Borough of Metuchen – TA 2018 – Grove Avenue and Eggert Avenue Bicycle Lanes
Borough of Metuchen, Middlesex County
Preliminary Engineering Phase
Design Consultant: NV5
Virtual Public Information Center
COMMENT RESPONSE SUMMARY

Prepared By: NV5 and Metuchen Borough

Progress Print: November 8, 2021

SIGN LEGEND:

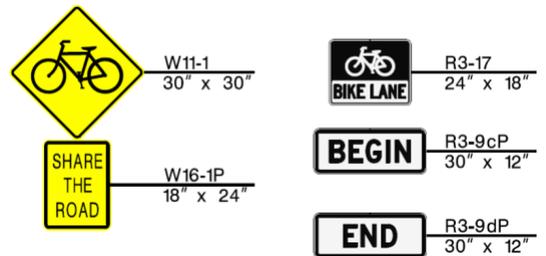
14. What is the status of signage with this project? Concern expressed about sign clutter including a statement that numerous signs were installed previously as part of an earlier project.

Response | Proposed signage included in the proposed improvements will be in accordance with the Manual of Uniform Traffic Control Devices (MUTCD), National Association of City Transportation Officials (NACTO) and New Jersey Department of Transportation (NJDOT) guidance. This is for the safety of all road users.

In areas with shared lane markings, the proposed signage includes Bicycle (W11-1) and "Share the Road" (W16-1P) to indicate to bicyclists and motorists that bicycles may be present within the travel lane. In areas with proposed bicycle lanes, a Bike Lane (R3-17) sign will be installed, with "Begin" (R3-9cP) and "End" (R3-9dP) present at the beginning and end of bicycle lanes (as the bicycle lanes pause in areas where it transitions to shared lane markings. Existing signs that are no longer applicable (for instance, "share the road" signs in areas with proposed dedicated bicycle lanes) will be removed. Reference the plans presented during the Virtual Public Information Center (available on the Metuchen Borough website at the link provided) for more information.

In total, 27 existing signs will be removed (existing bicycle plaque and "share the road" signs that are no longer applicable) and 33 signs will be installed for the proposed shared lane markings (bicycle plaque and share the road signs) / bicycle lanes.
